AERONAUTICAL CHARTING FORUM
Instrument Procedures Group
April 29, 2014

FAA Control # 14-01-315

Subject: 90 Degree Airway-to-RNAV-IAP Course Change Limitation; Arrival Holds

V-343/JOXIT Feeder WP, Dillon, Montana

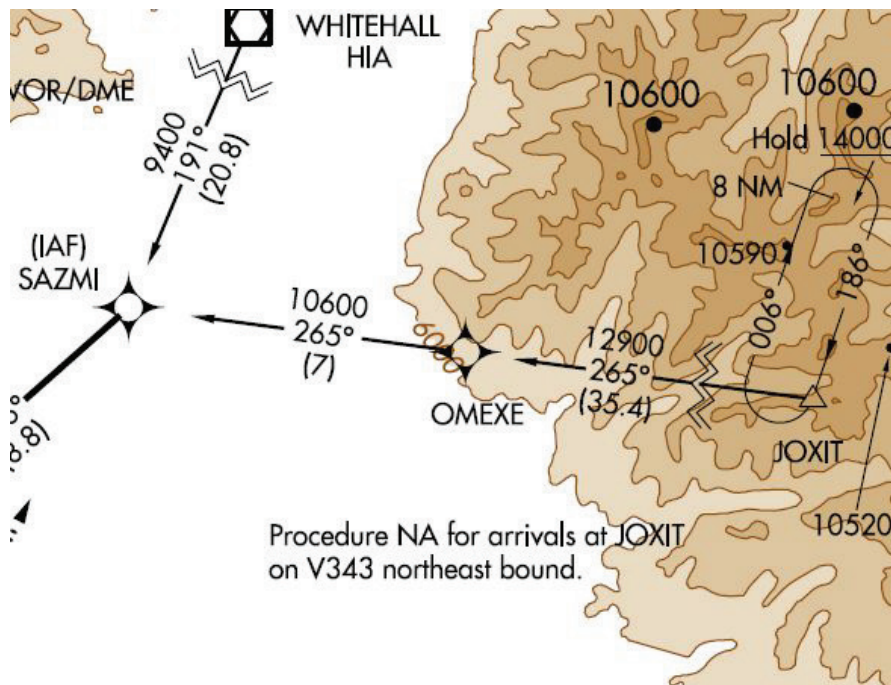
A recently implemented example is on the Dillon, Montana (KDLN) RNAV (GPS) Runway 17 SIAP, for an arrival on Victor Airway 343 from the south (illustrated in the attachment)*. Note that the course change from V-343 northbound onto the JOXIT feeder route is 101 degrees and prohibited by the JOXIT note. Instead, the JOXIT arrival holding pattern shown on the approach chart is an implicit course reversal to permit entry onto the JOXIT feeder route arriving on V-343 from the south.

NBAA conducted a simulation of the JOXIT configuration using a Garmin G-3000 trainer. We did this at 265 KIAS at 15,000 in an ISA atmosphere with no winds aloft. As a test, we intentionally “violated” the procedure note limitation by arriving at JOXIT from the south on V-343 and turned on to the feeder segment. The avionics simulation made a very good flyby of JOXIT. We also did this JOXIT flyby at a 120 degree angle and at 310 KIAS. Again, the result was a very good flyby at JOXIT. However, when we arrived at JOXIT from the south on V-343 and entered the charted arrival hold at 15,000, 265 KIAS (descending to 14,000 in the hold) the avionics could not correctly sequence the turn from the hold to the JOXIT feeder route. The simulation did not attempt to start the turn to the west until having overflown JOXIT, thus treating it like a “fly over” WP.

*Note: A very recent change to V343 removed JOXIT from the airway structure. However, the issue remains since the limitation is reflected on SIAP chart and is found on other procedures within the NAS.
